Access Compliance Report Public Rights-of-Way (Curb Ramps)

Main Street: CARLSBAD_DR Cross Street: ESTES_WAY Location: E

ADA ID: RPAT211019110001 Ramp Type: Type 1 - Perpendicular Diagonal Initial Pass/Fail: Pass Overall Compliance: No Severity Score: 14

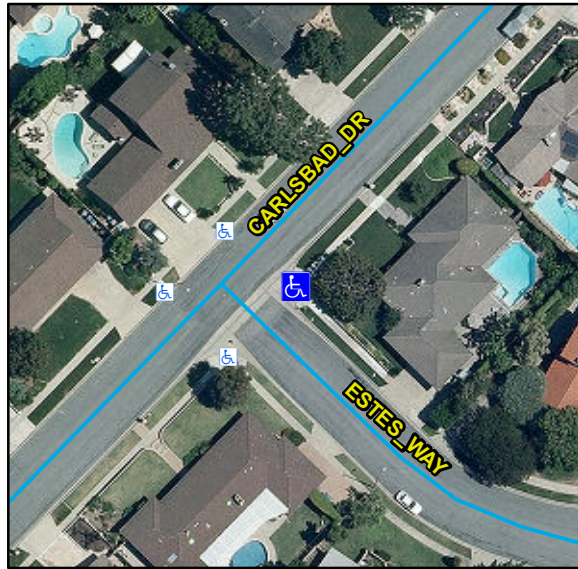
R204.3, R304.2.1, R304.2.2-Perp, R304.3.2-Para, R305, STD 1115

Remove & Replace Curb Ramp With Two New Directional Ramps or Equivalent.
